ADDENDUM NO. 01

PROJECT: WCS – Hunt HS – Athletics Renovation

CPL PROJECT NO. R22.16900.00

DATE: 10.16.2023

Drawing Number: C103

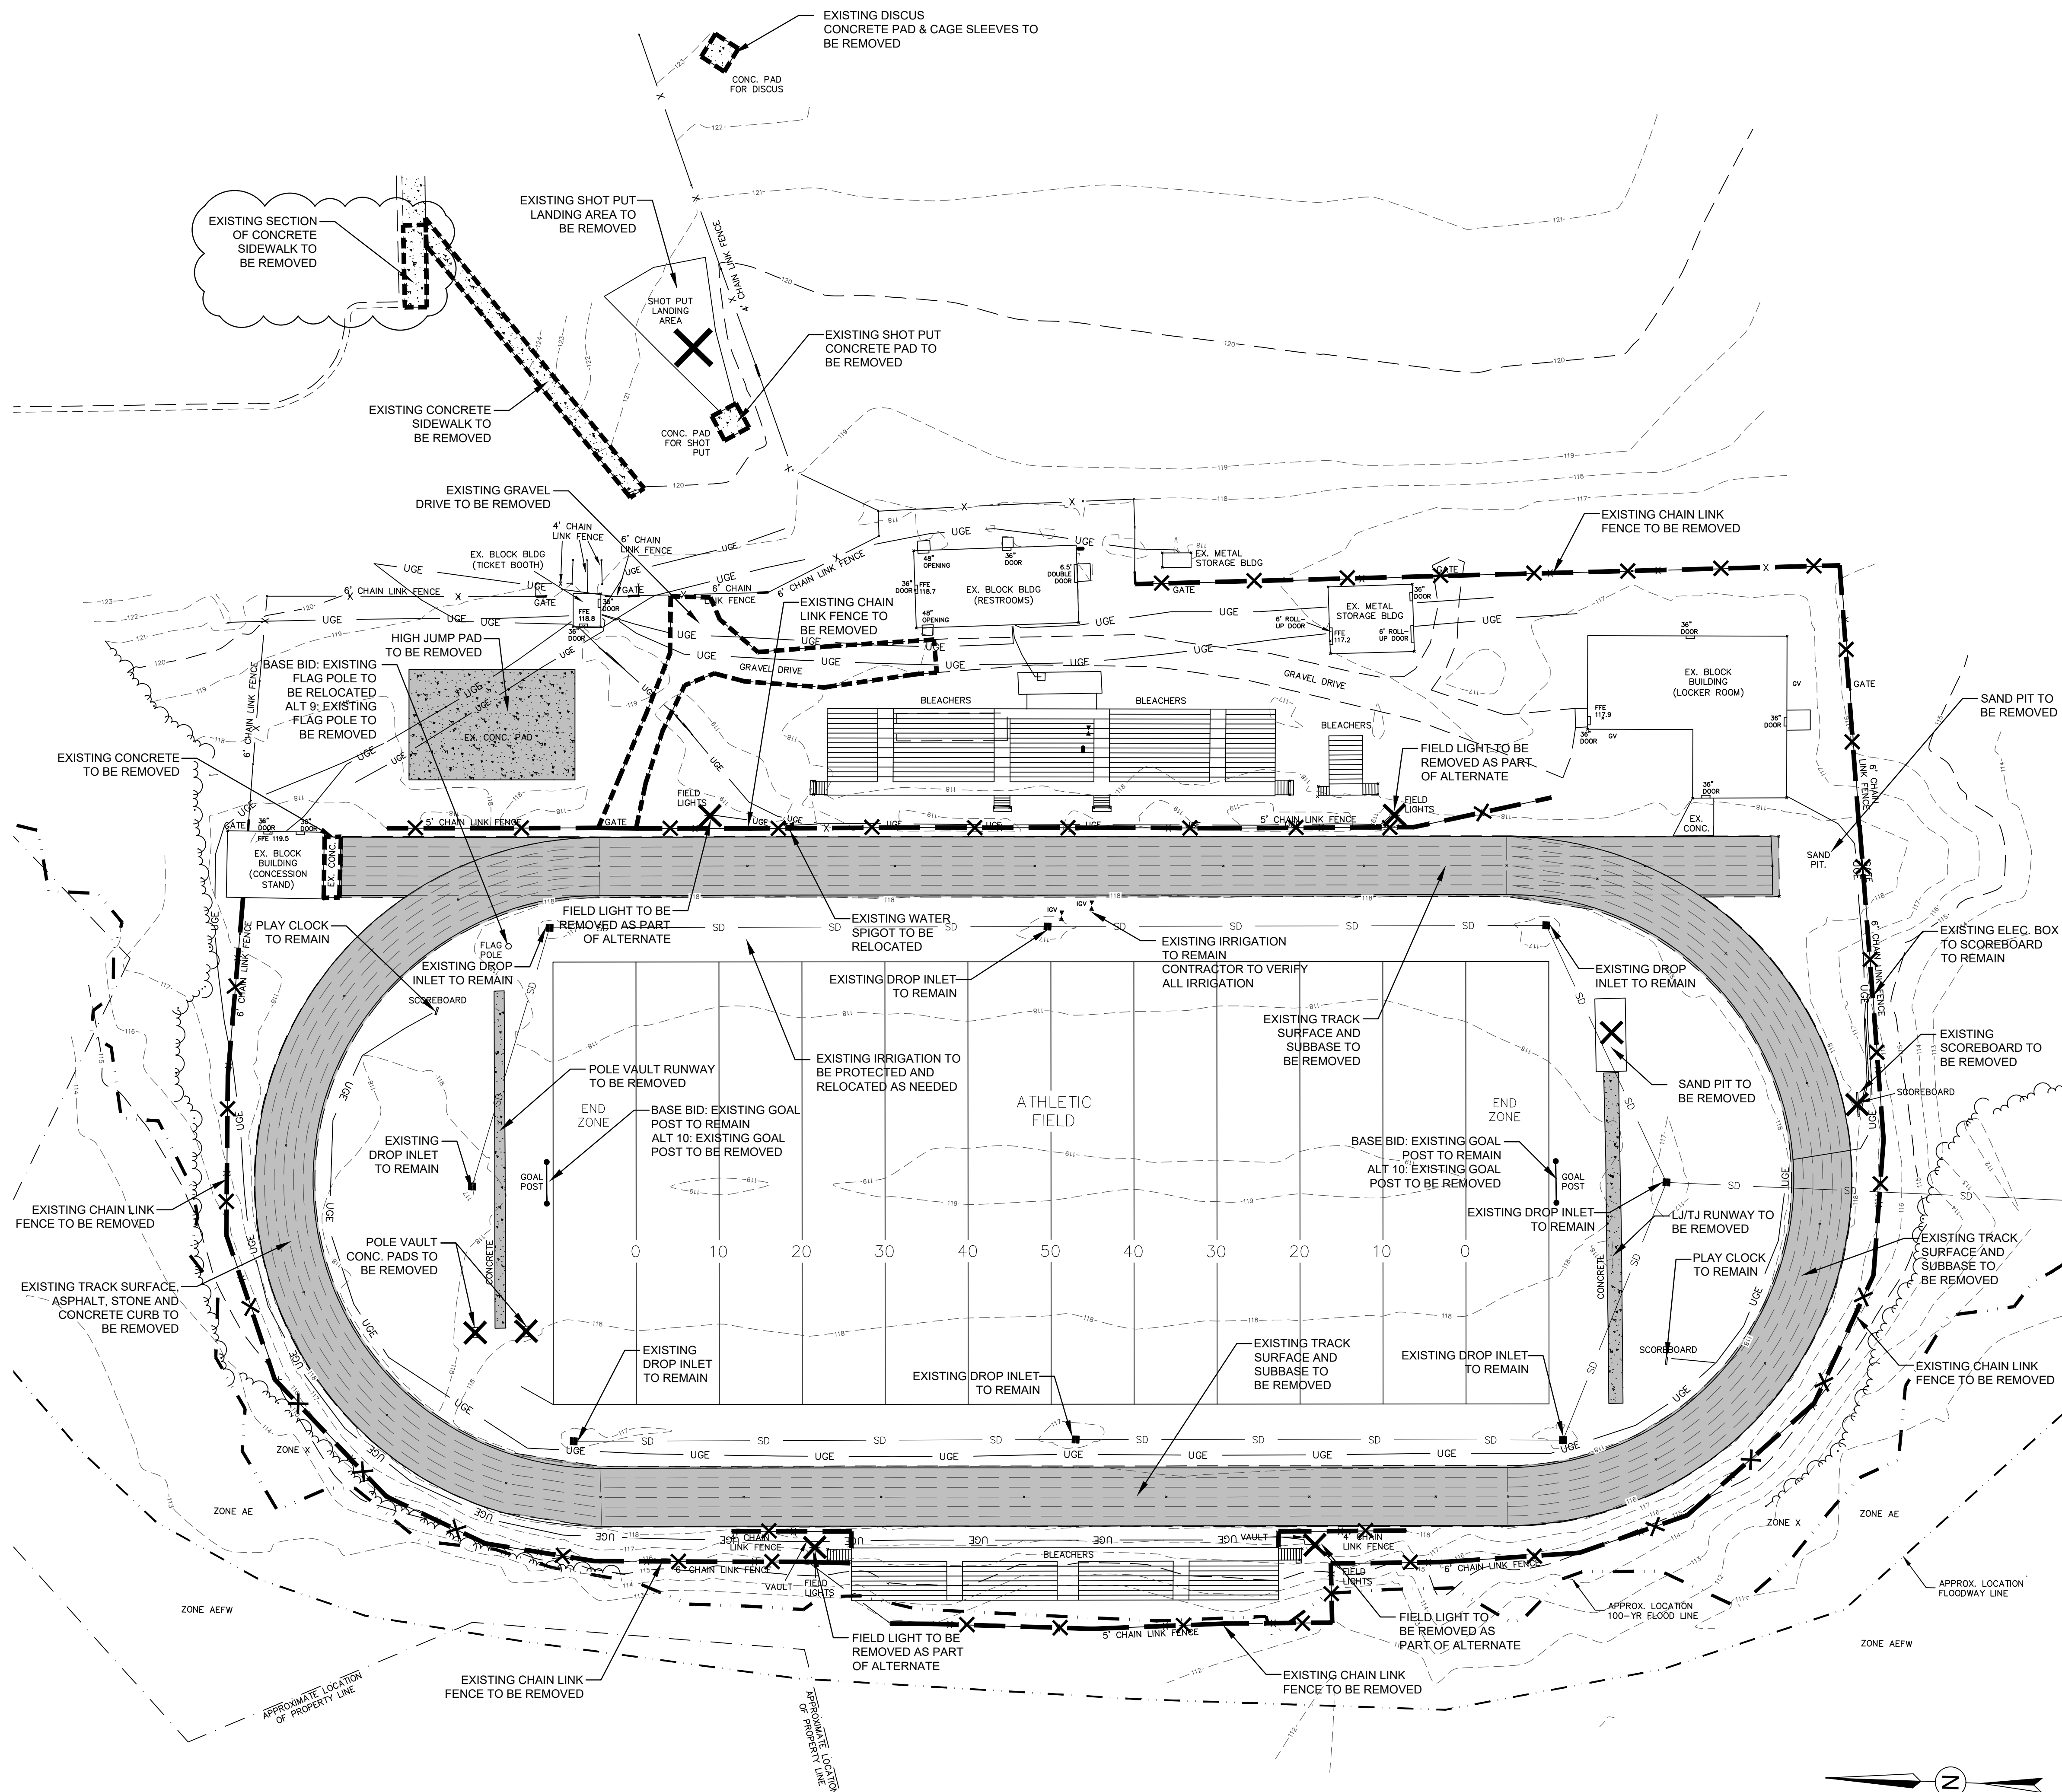
C103 – Demolition Plan

Updated to show two (2) ADA parking spaces.

Drawing Number: C300

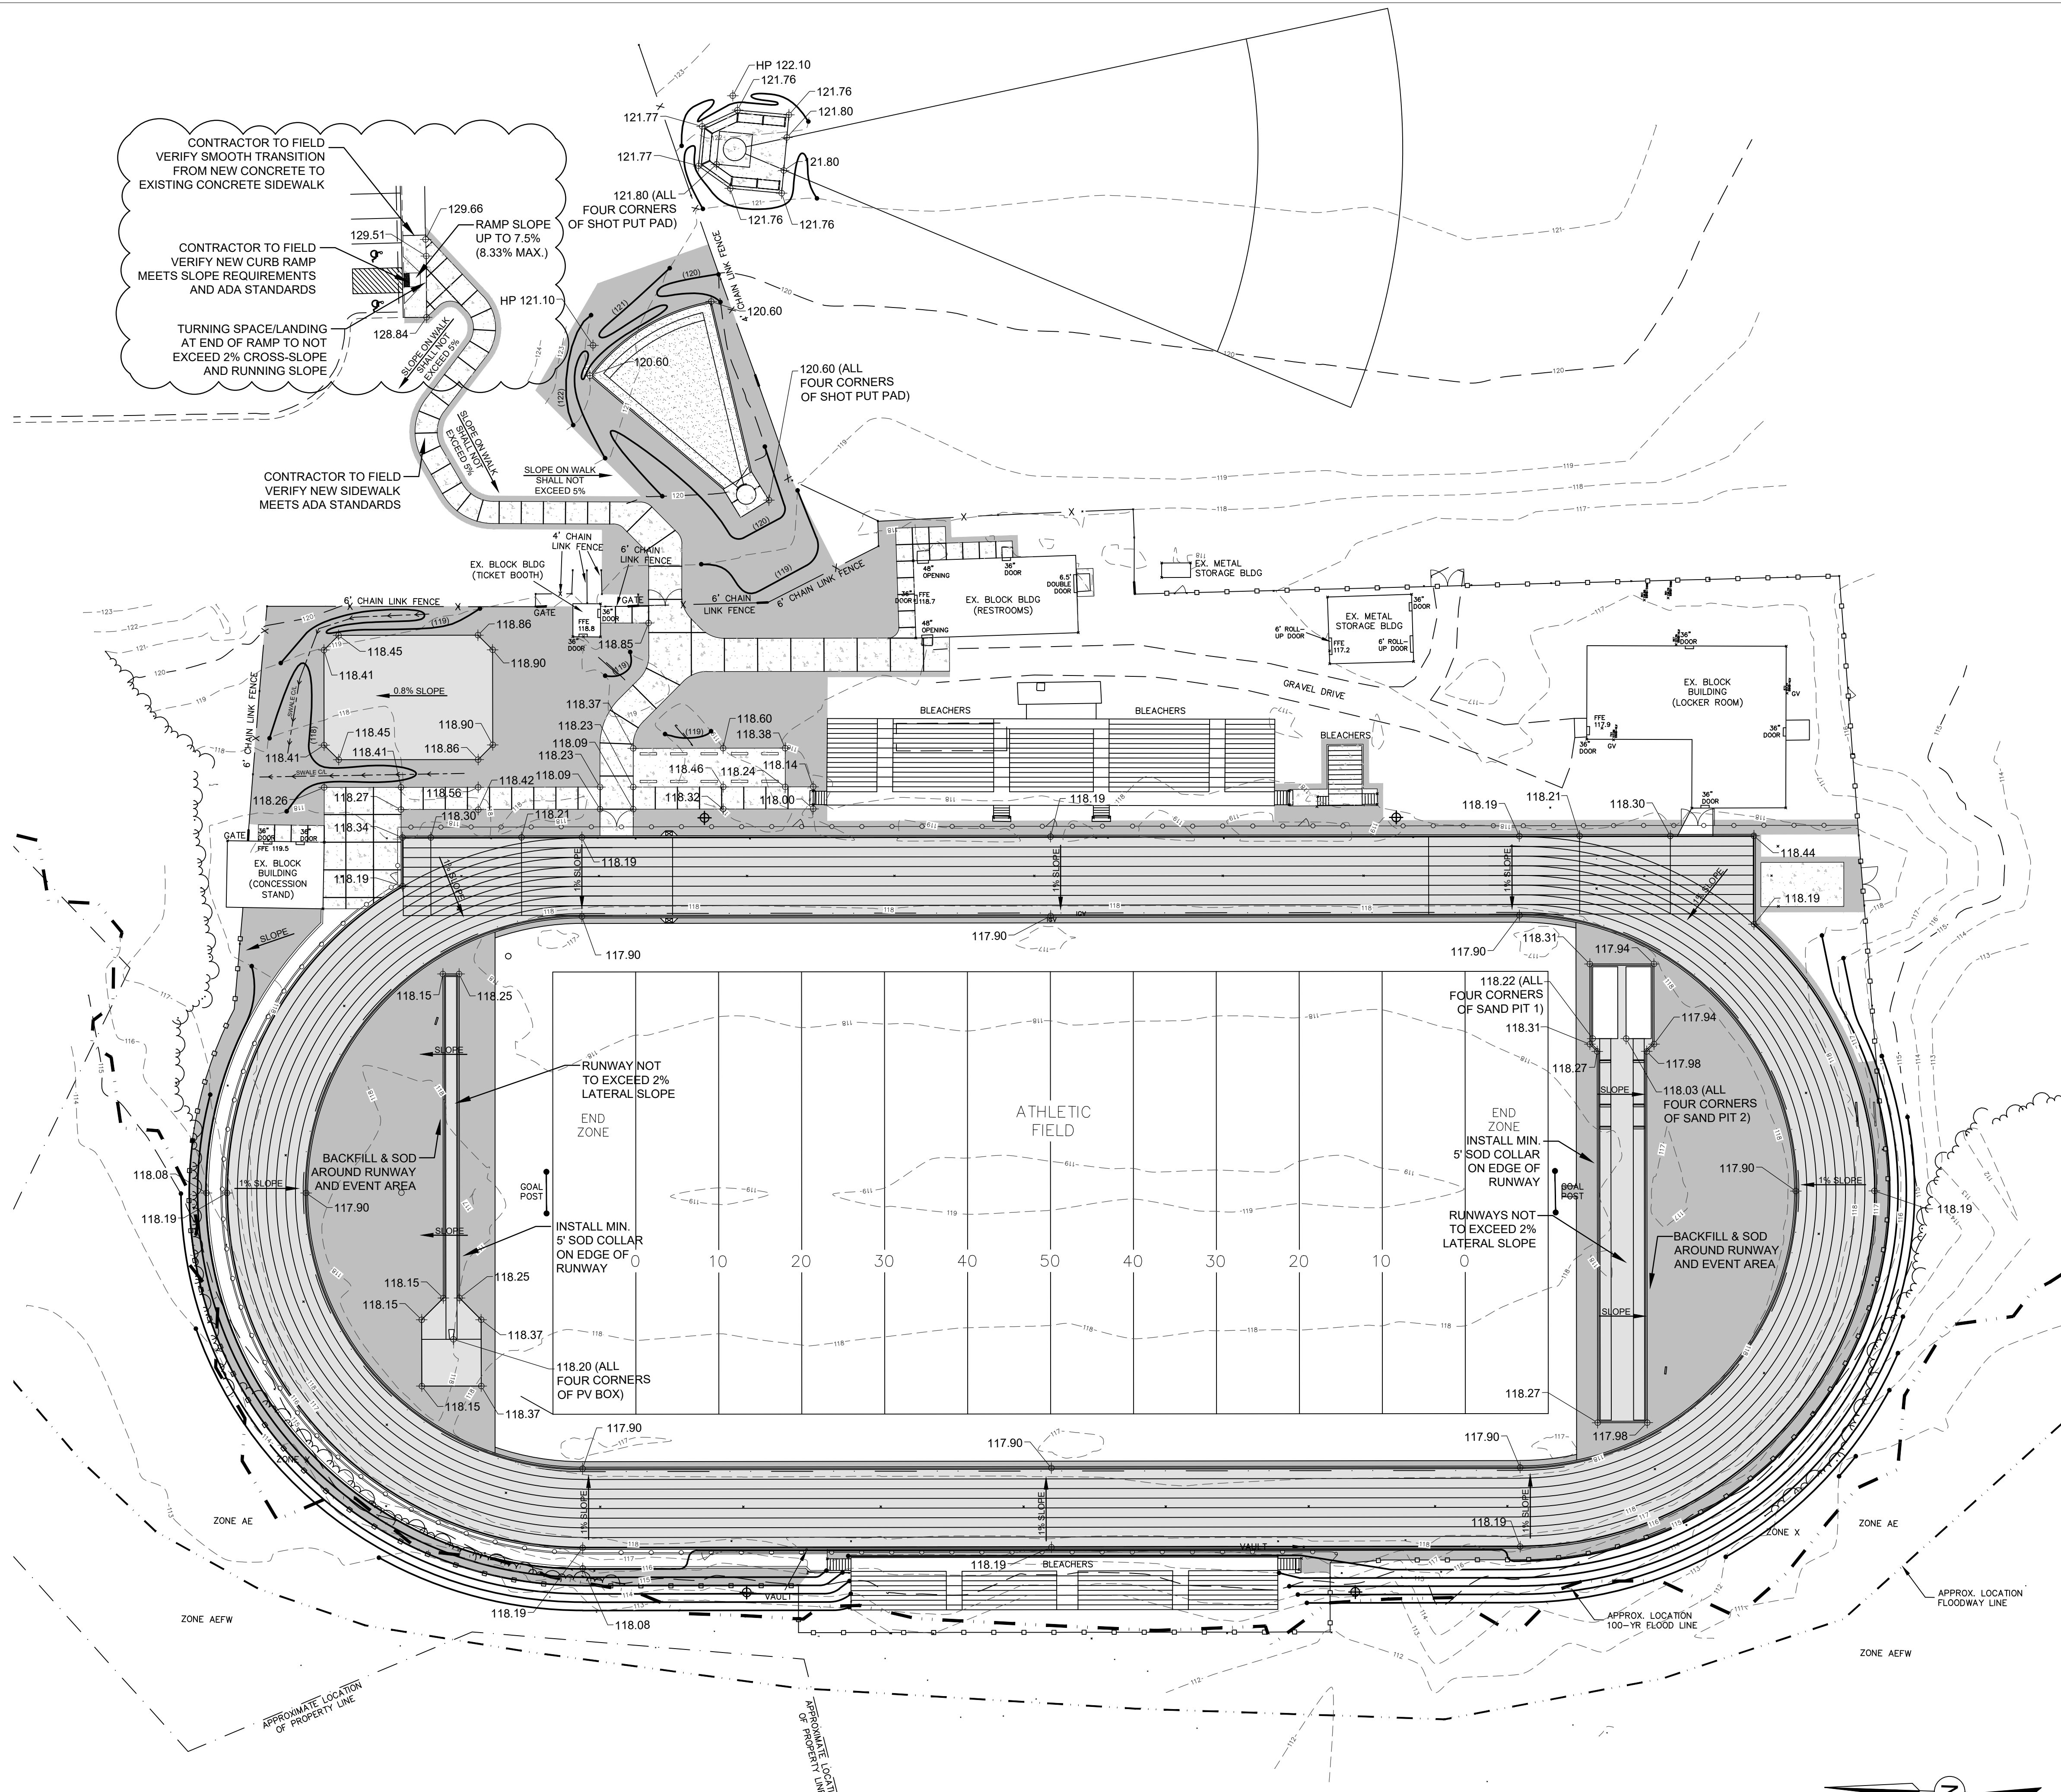
C300 – Grading Plan

Updated to show two (2) ADA parking spaces.

SHEET INFORMATION
 Issued: 8/28/23 Scale: 1" = 30'-0"
 Project Status: CONSTRUCTION DOCUMENTS
 Drawn By: BG Checked By: DD
 Drawing Title: Drainage Plan
 Drawing Number: C301

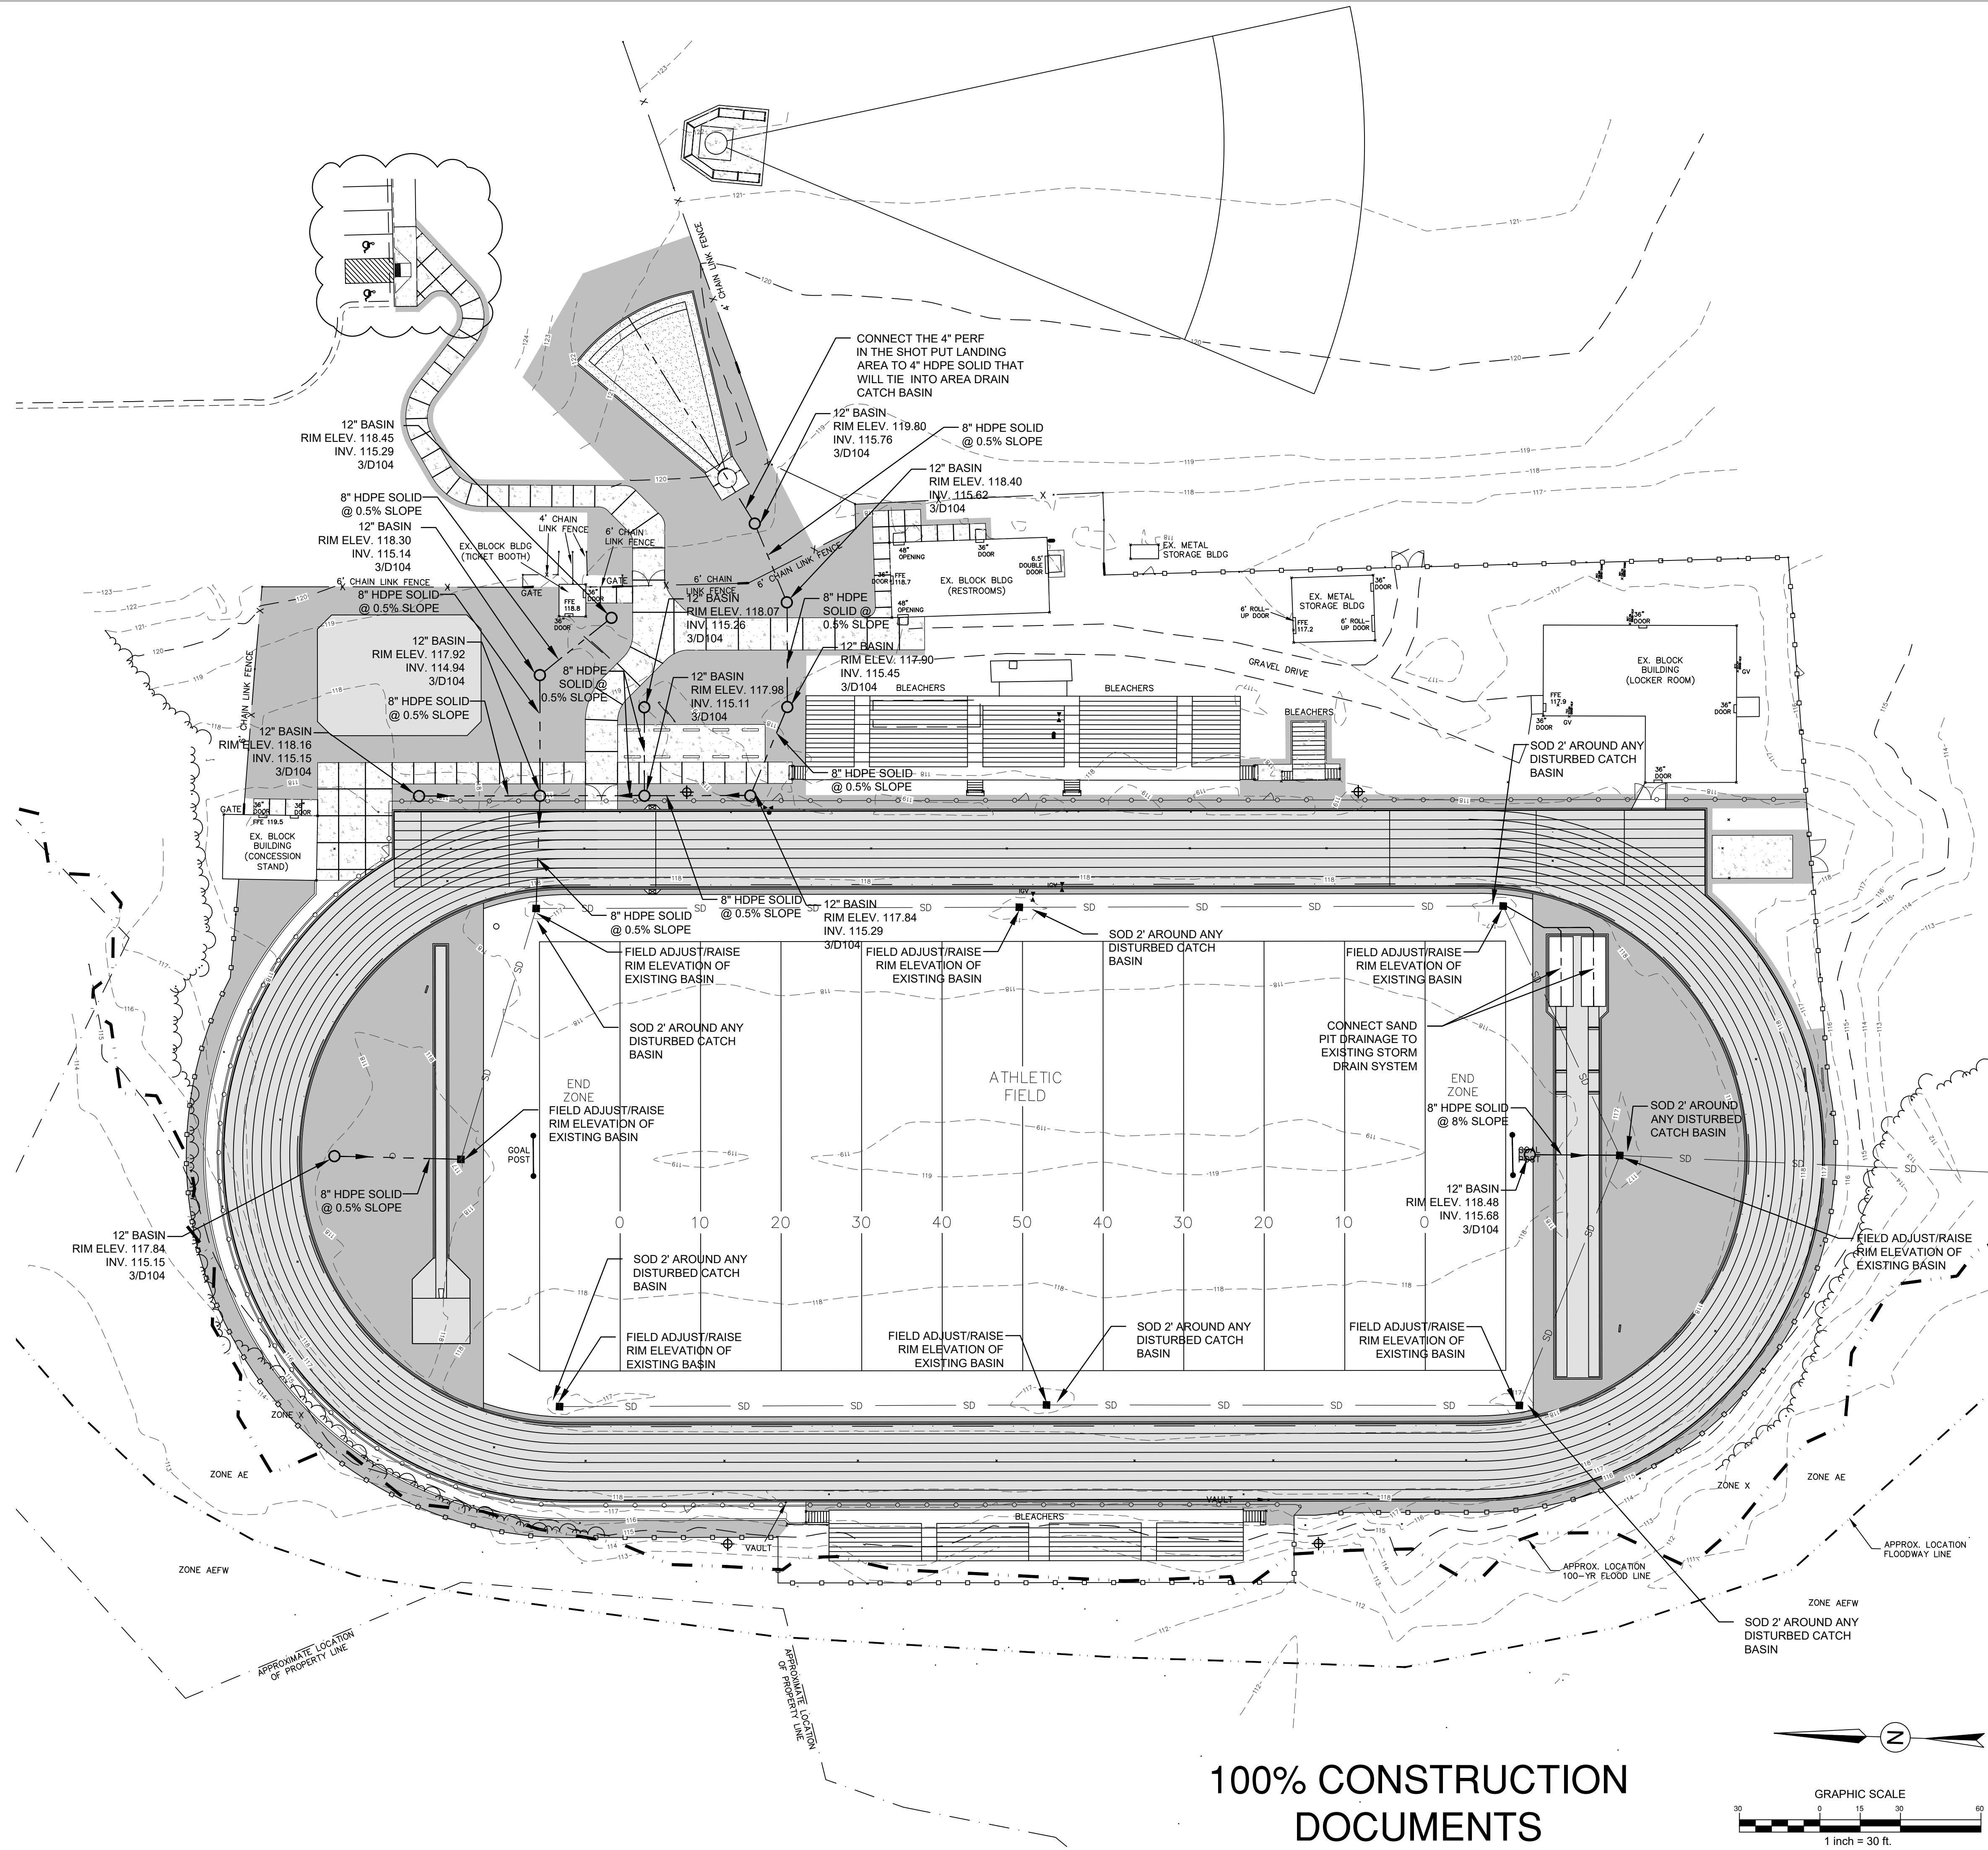
C301 – Drainage Plan

Updated to show two (2) ADA parking spaces.
